General Bid Bulletin No. 15
16 July 2021

**THE MALOLOS-CLARK RAILWAY PROJECT AND THE NORTH-SOUTH RAILWAY
PROJECT SOUTH LINE COMMUTER PACKAGE CP NS-01: PROCUREMENT OF
ELECTRICAL AND MECHANICAL SYSTEMS AND TRACK WORKS (IFB No: 21-040-3)**

PACKAGE CP NS-01: E&M SYSTEMS AND TRACK WORKS
General Bid Bulletin No. 15
Annex A

PACKAGE CP NS-01: E&M SYSTEMS AND TRACK WORKS
General Bid Bulletin No. 15
Annex B

MALOLOS - CLARK RAILWAY PROJECT (MCRP) NORTH SOUTH RAILWAY PROJECT-SOUTH (NSRP-SOUTH)	
Package CP NS-01 : Bidding Documents	
SUBSTATION LAYOUT (SS No. S15)

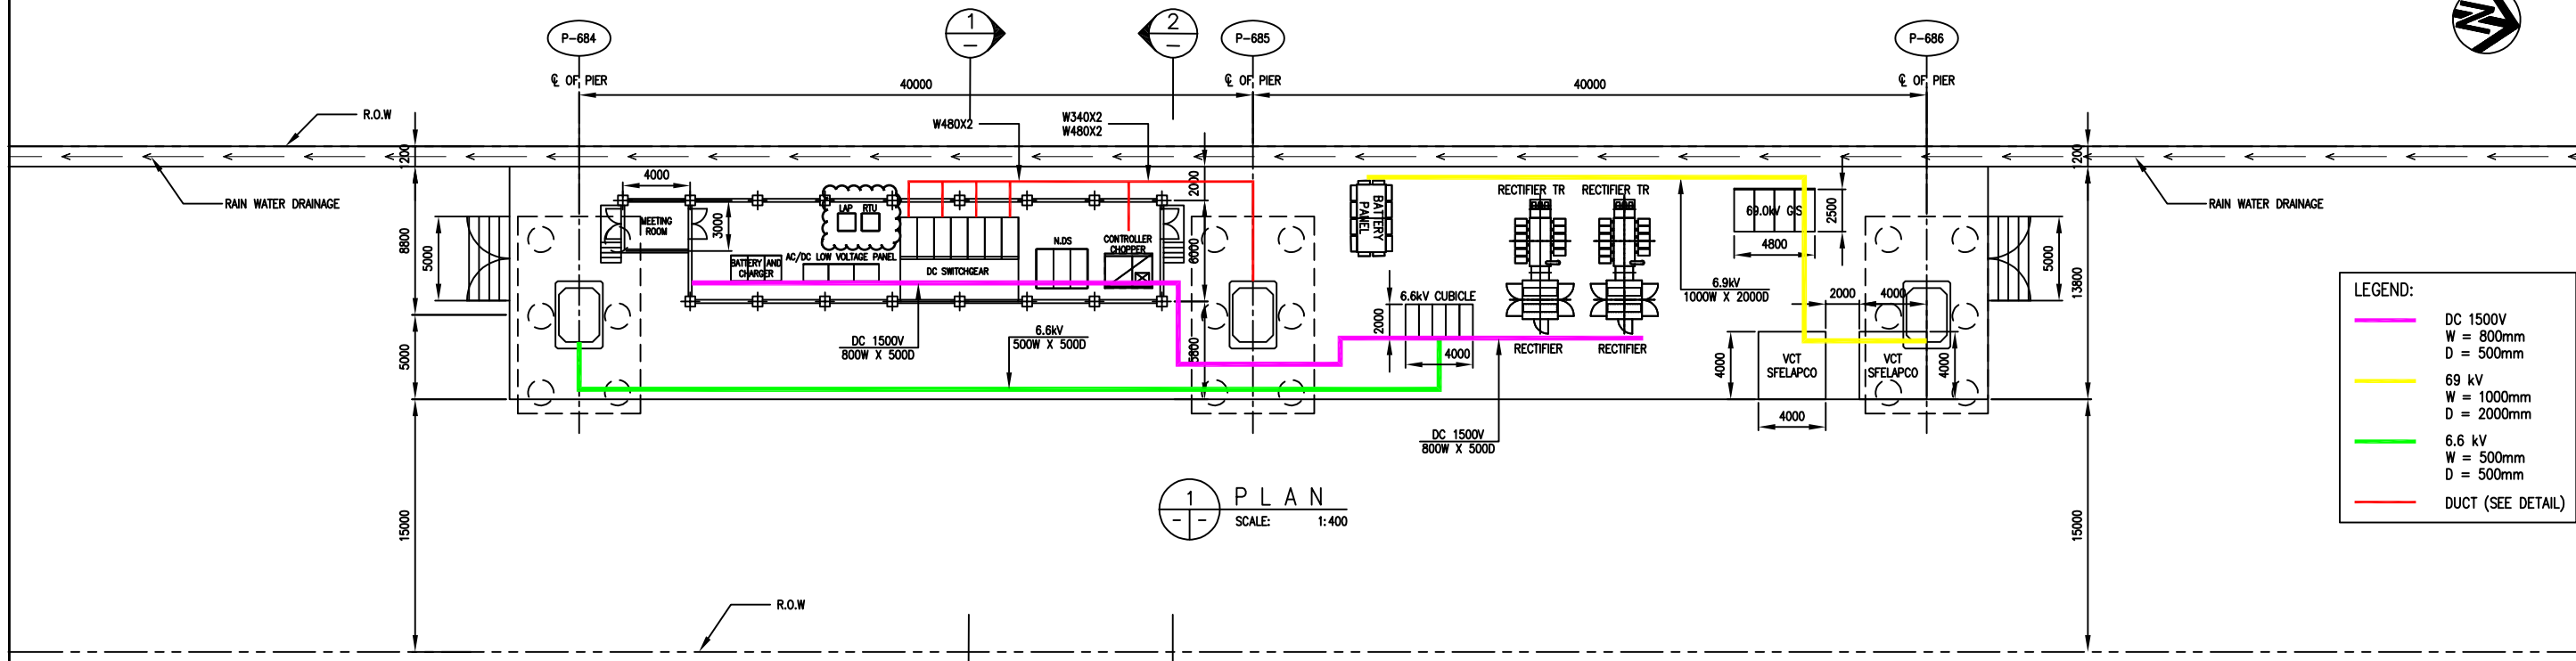
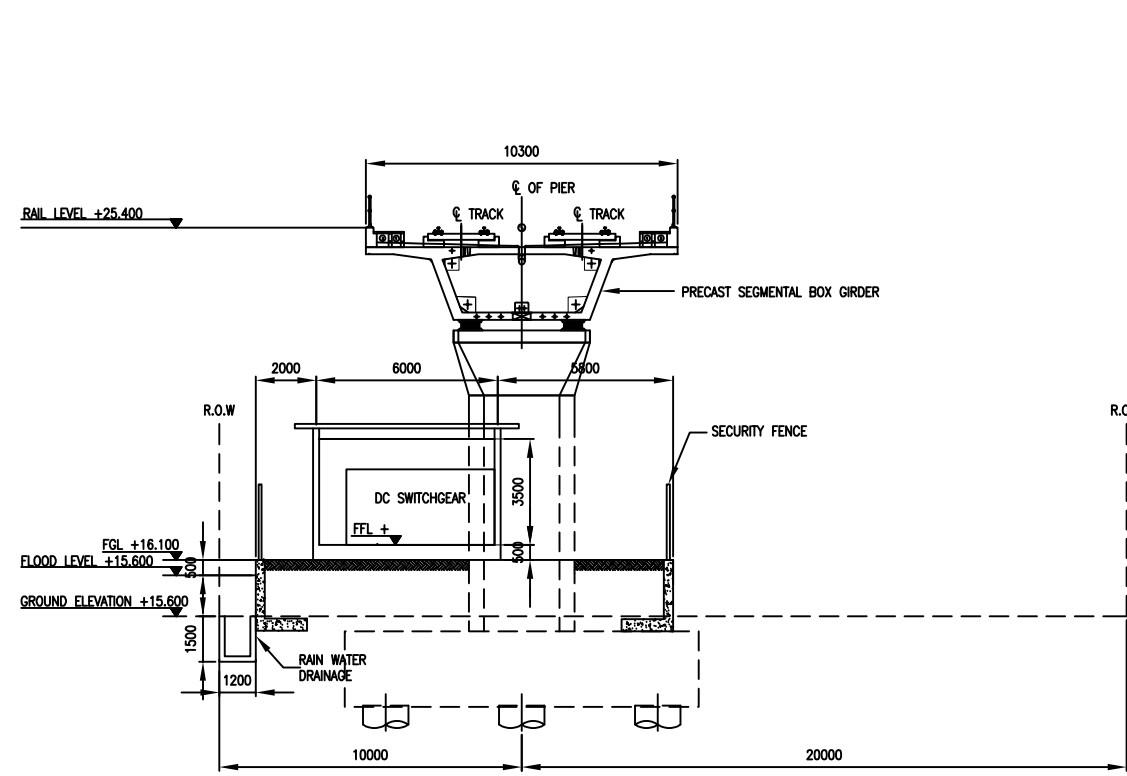
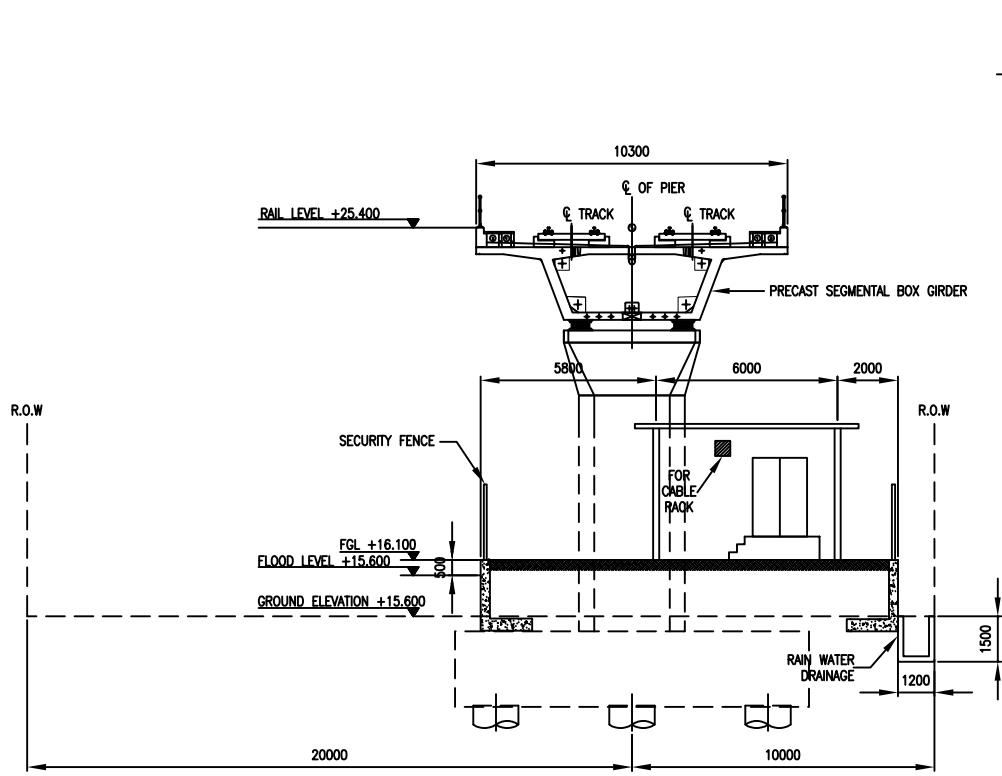
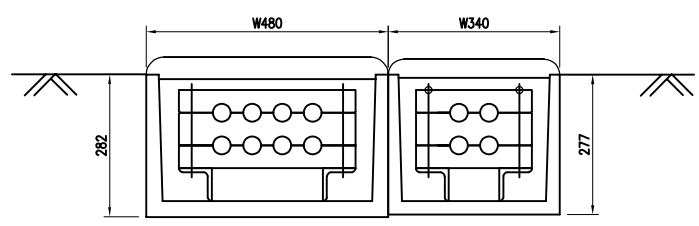
Volume III Part 2 – Employer’s Requirements d) Employer’s Drawings		
7	Part 2 Vol.3 E_M Version 11.0 FINAL Rev. A. ERD (a) page 164	Revised Traction Power Feeding System Drawing
8	GBB-9 Annex B, Item No.16	Substation Layout Drawings (SS No. 10) to (SS No. 22) “Local Annunciator Panel Added”

VERSIONS	DATE	DESCRIPTION
00	02 MAR 2021	ISSUED FOR REFERENCE
01	09 JUN 2021	RESISTOR CHANGED TO BATTERY POST
02	21 JUN 2021	LOCAL ANNUNCIATOR PANEL ADDED

SUBSTATION LAYOUT
 (SS No. S16)

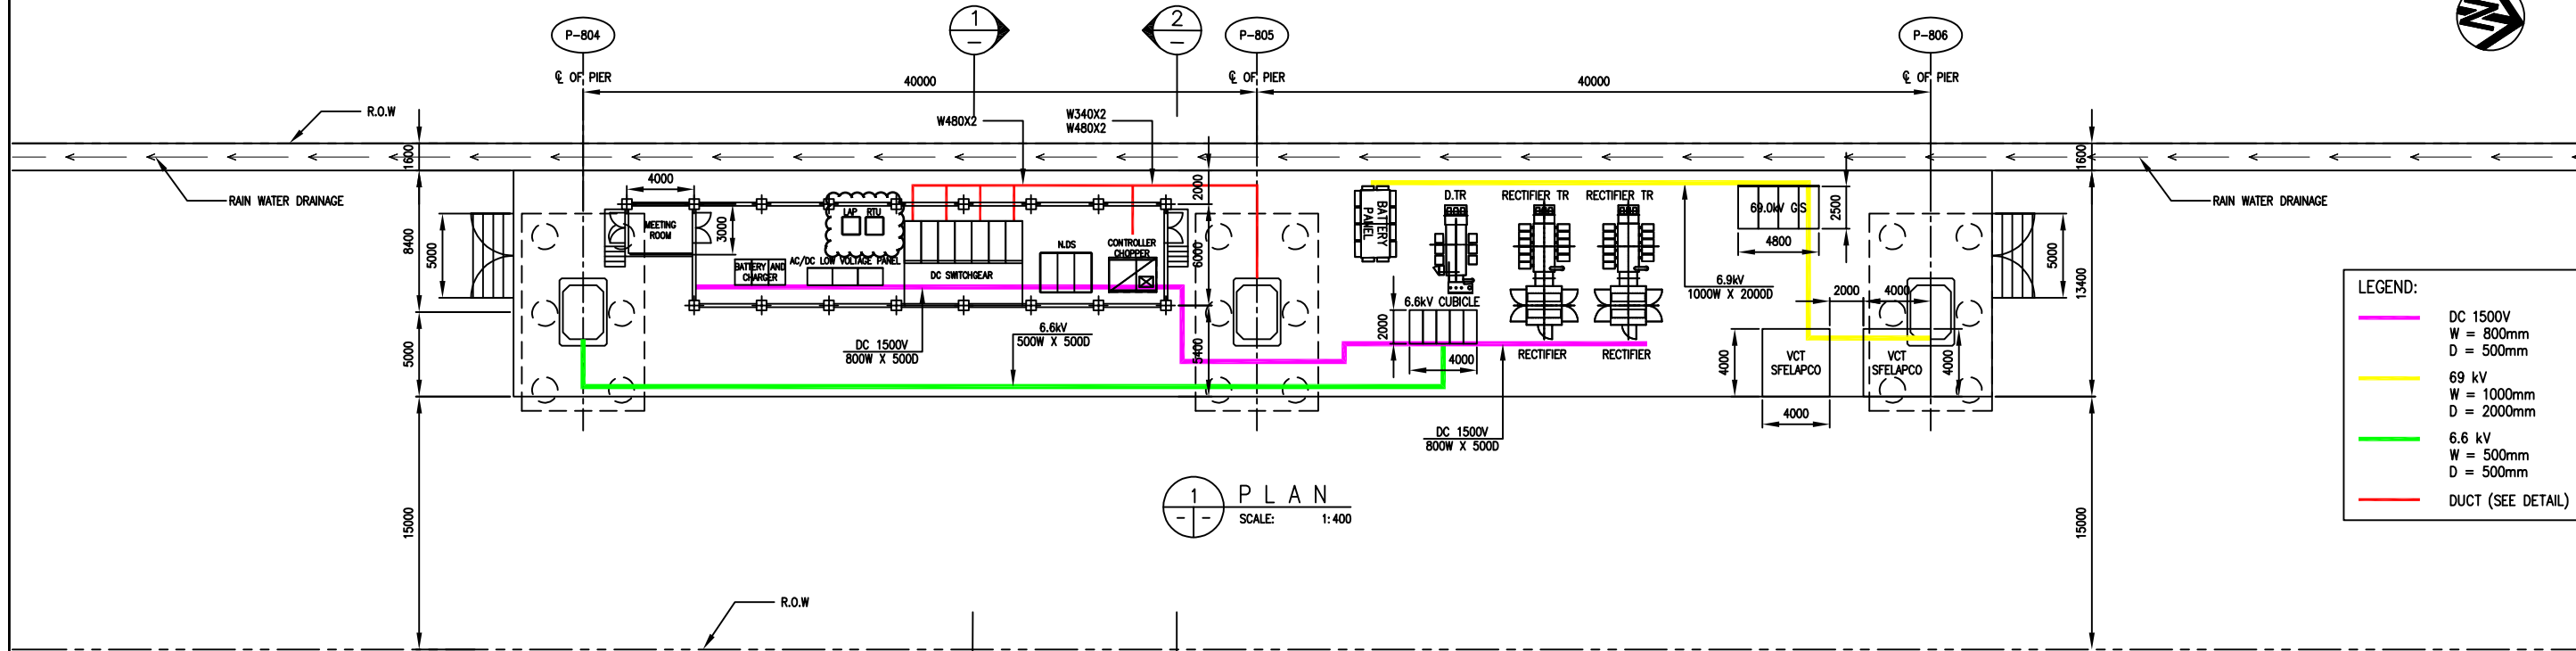
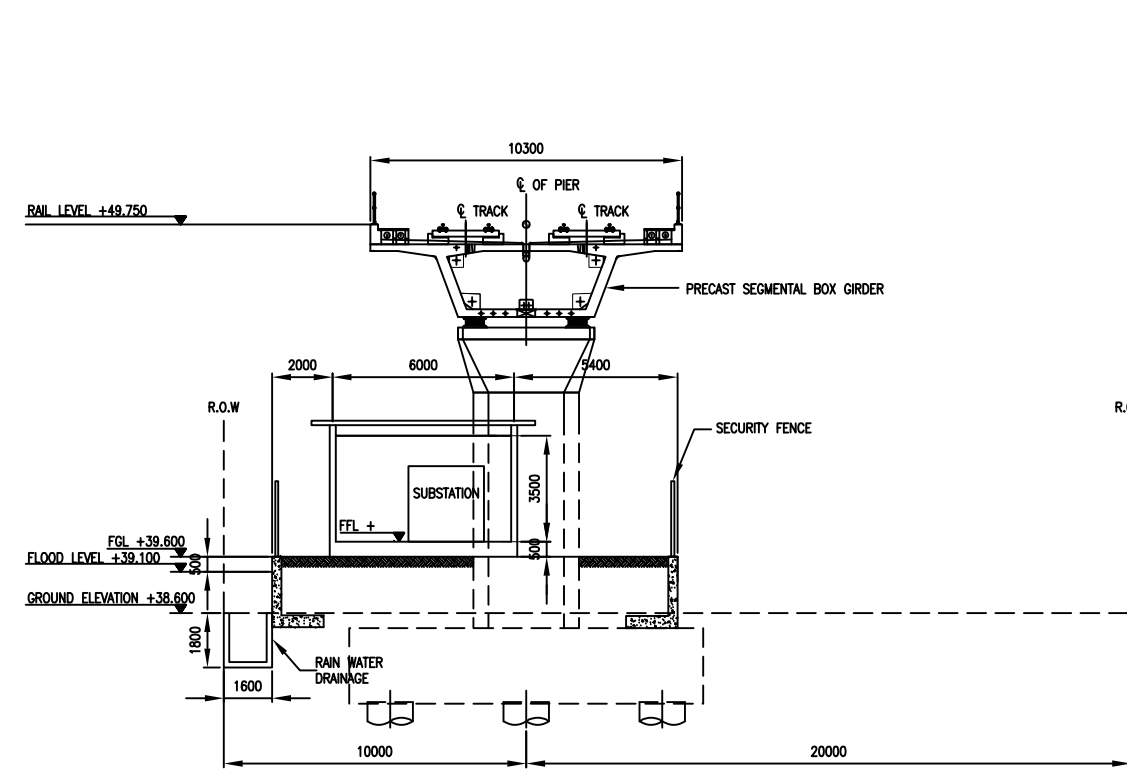
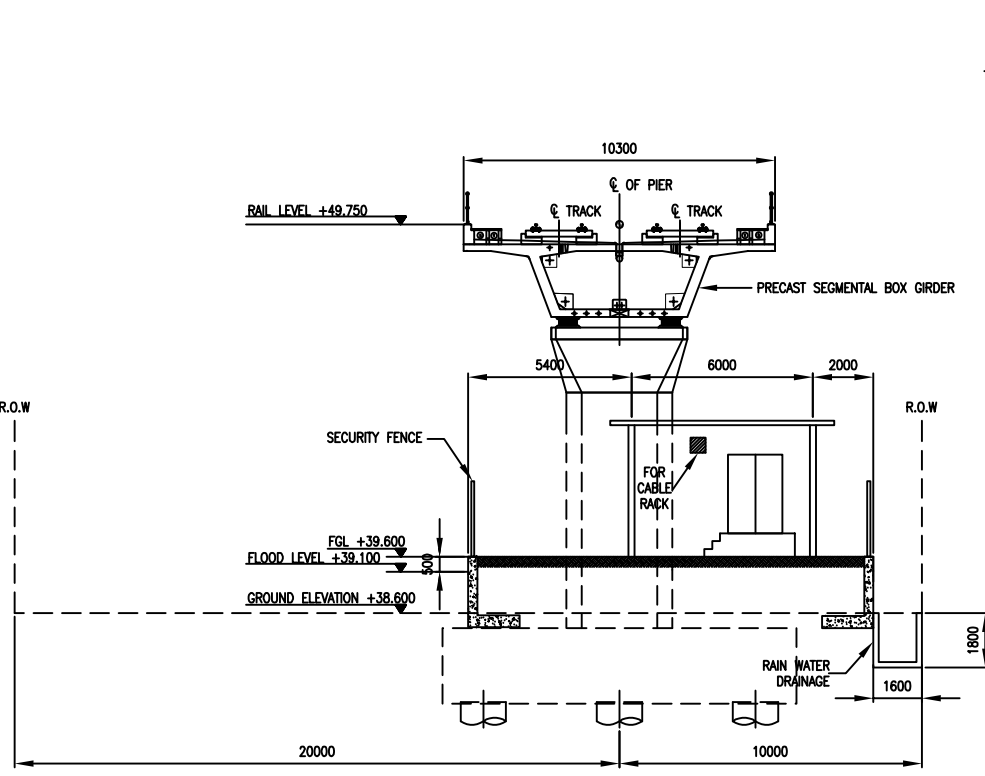
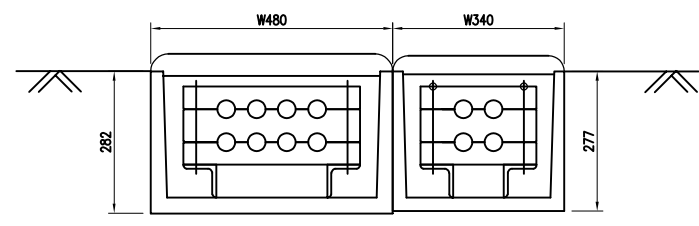
VERSIONS	DATE	DESCRIPTION
00	02 MAR 2021	ISSUED FOR REFERENCE
01	09 JUN 2021	RESISTOR CHANGED TO BATTERY POST
02	21 JUN 2021	LOCAL ANNUNCIATOR PANEL ADDED

SUBSTATION LAYOUT
(SS No. S17)

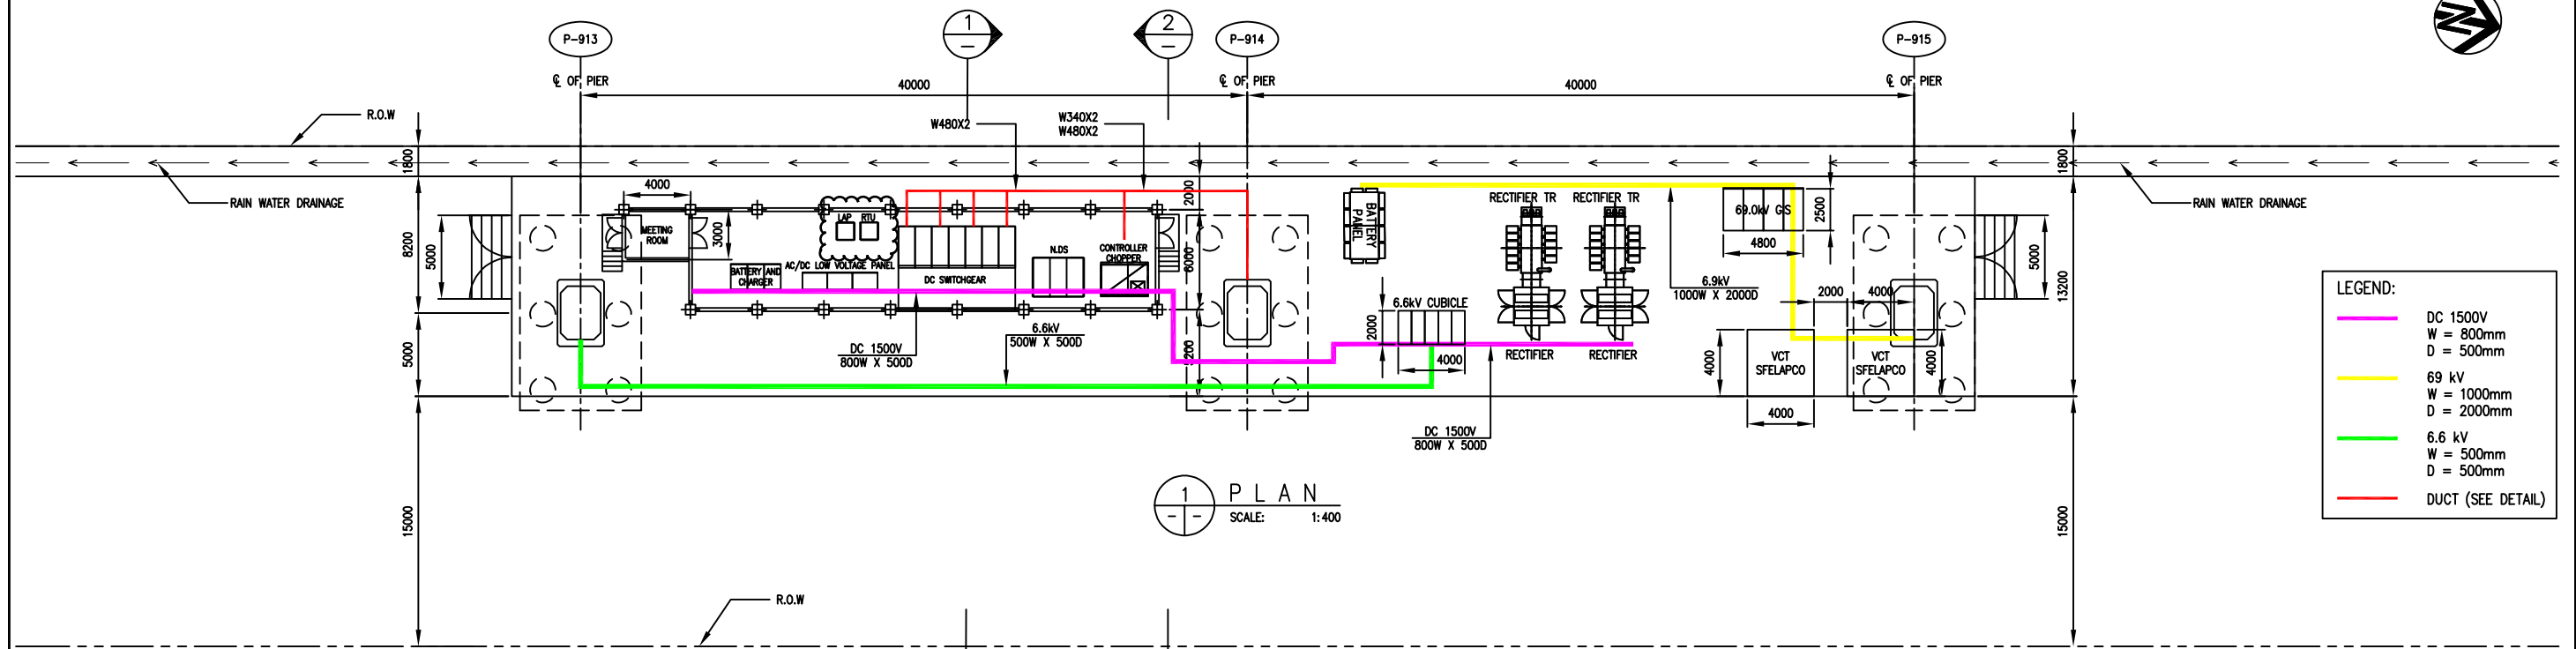
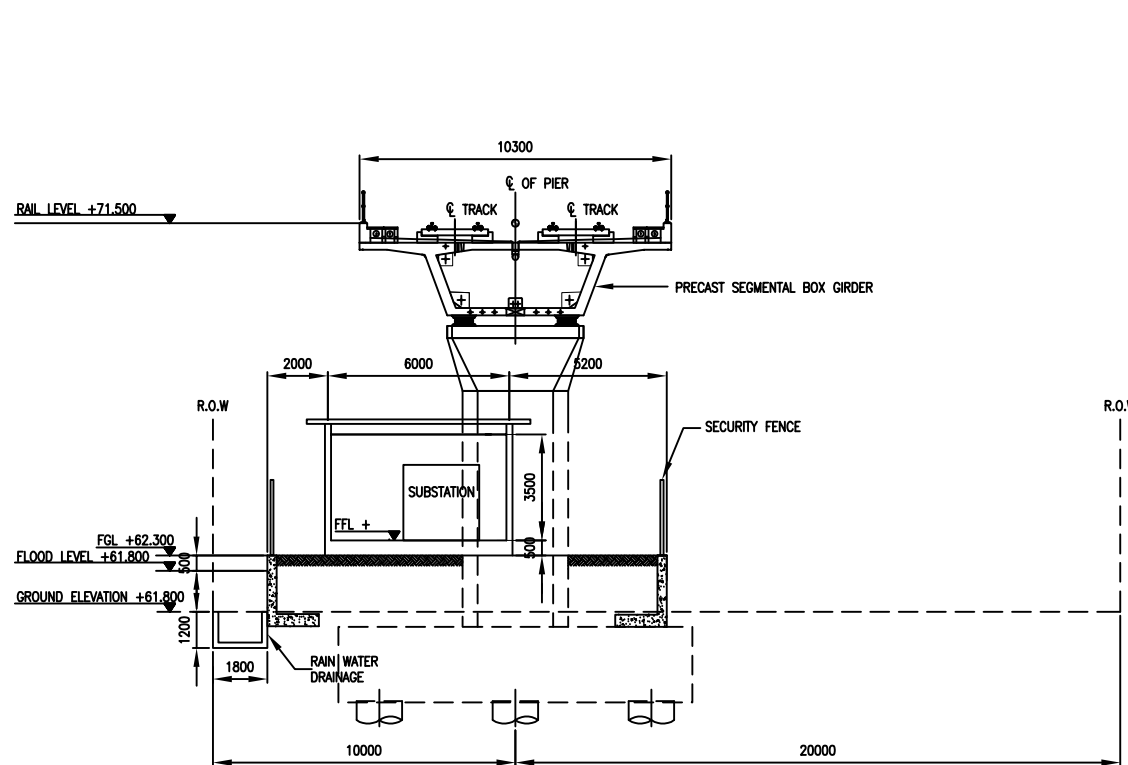
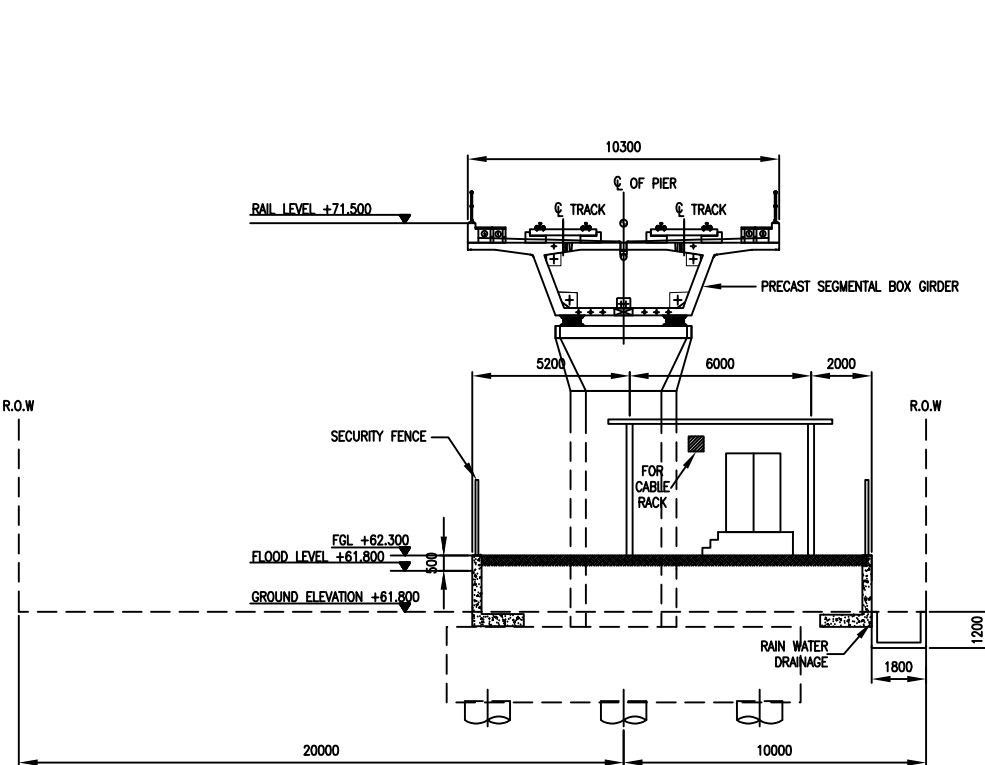
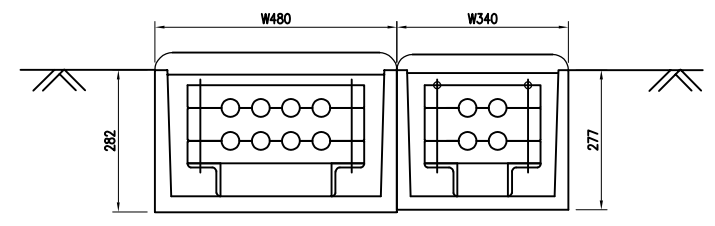
VERSIONS	DATE	DESCRIPTION
00	02 MAR 2021	ISSUED FOR REFERENCE
01	09 JUN 2021	RESISTOR CHANGED TO BATTERY POST
02	21 JUN 2021	LOCAL ANNUNCIATOR PANEL ADDED
